Building Manager: [Robert T. Mason, masonr@science.oregonstate.edu](mailto:masonr@science.oregonstate.edu)
 Assessment Date: 4/18/2022
 Assessment Number: **10565**
 Location: Cordley Hall Entire
 Reinspection date:

A joint fire safety inspection of the facility listed above was performed by the Environmental Health & Safety - Fire and Life Safety and the Corvallis Fire Department. These fire safety deficiencies could result in a fire or jeopardize the safety of those occupying the facility. Please see that these items are corrected immediately and no later than the scheduled reinspection date noted with this report. If you have any questions regarding this inspection, please email Brian Lilley (EH&S - Fire and Life Safety) at brian.lilley@oregonstate.edu.

Room 4027B

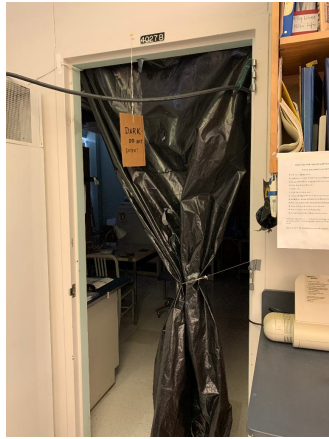
Priority code	Standard in need of attention	Reg.Reference	Location	Resp	Observations & Recommendations	Date Corrected
2	Curtains, draperies, fabric hangings and other similar combustible decorative materials suspended from walls or ceilings shall be flame retardent, tested, and not exceed 10 percent of a specific wall or ceiling area.	2019 OFC 807.2 and 807.3	4027B:entrance	DEPT	Provide documentation of flame resistance tarp hanging in doorway or remove.
